Subject: Hunter Valley Operations North Continuation Project (SSD-11826681) and Hunter Valley Operations South Continuation Project (SSD-11826621) – Environmental Impact Statement

Detailed advice to DPE Planning & Assessment regarding the HVO North Open Cut Coal Continuation Project (SSD-11826681) and HVO South Open Cut Coal Continuation Project (SSD-11826621) – Environmental Impact Statement

Hunter Valley Flood Mitigation Scheme Assets

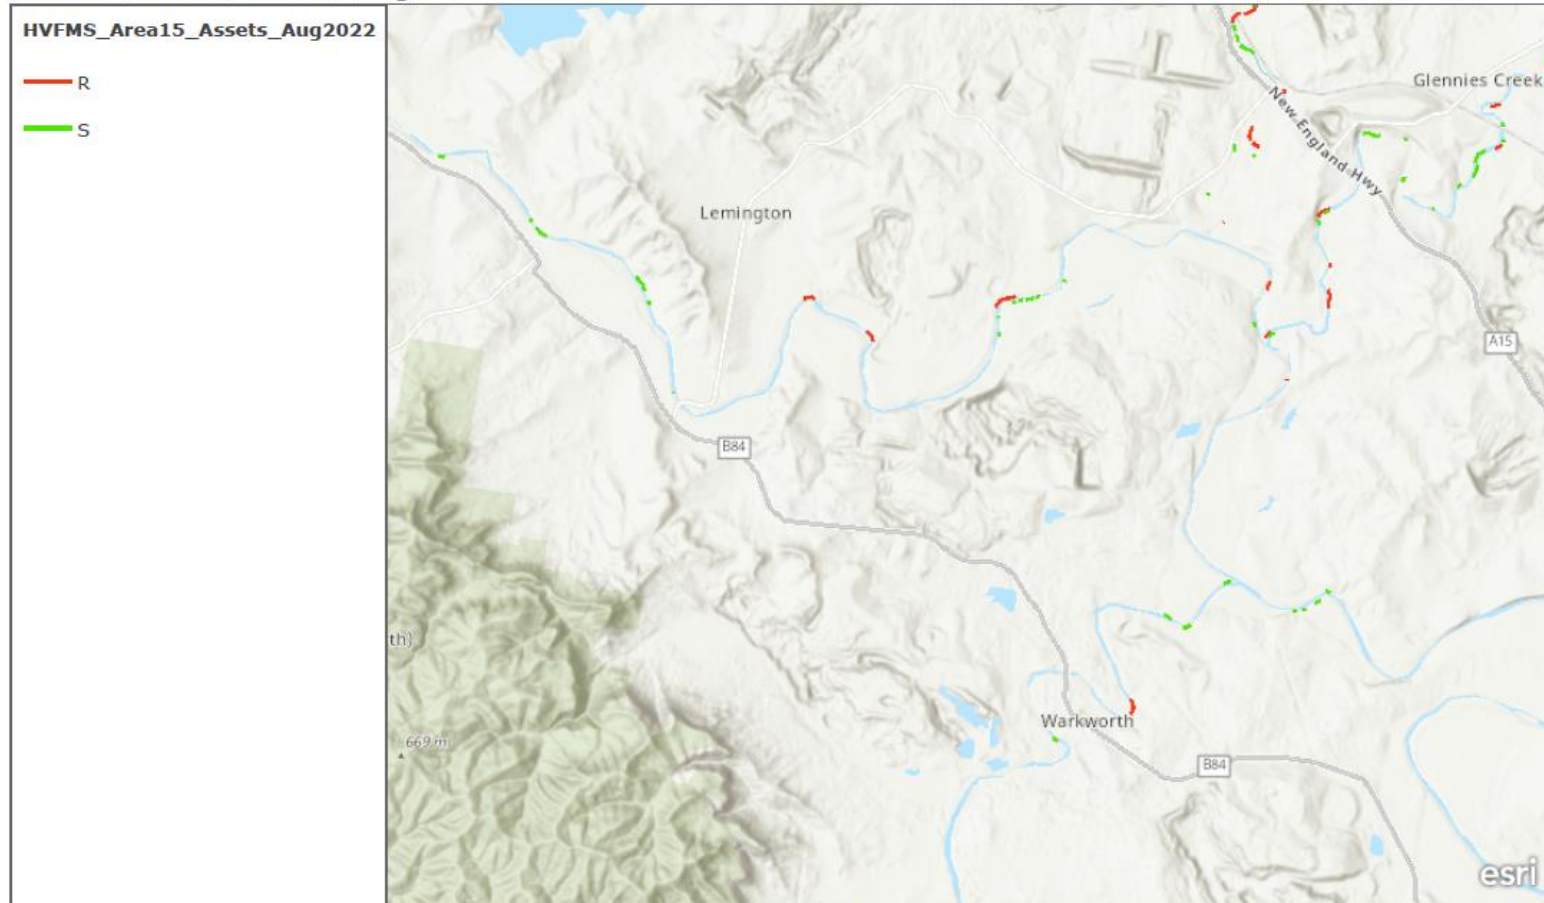
That works which will result in alterations to the hydrology of the Hunter River or its floodplain and tributaries be reviewed to ensure no impact to the structural integrity of Hunter Valley Flood Mitigation Scheme bank stabilisation works shown in Attachment B.

DPE Water is aware there are a number of old Hunter Valley Flood Mitigation Scheme bank stabilisation works on the Hunter River, Bowmans Creek and Wollombi Brook. These are depicted in Attachment B. Identification and assessment of these works in terms of potential impacts due to the project and mitigation is required.
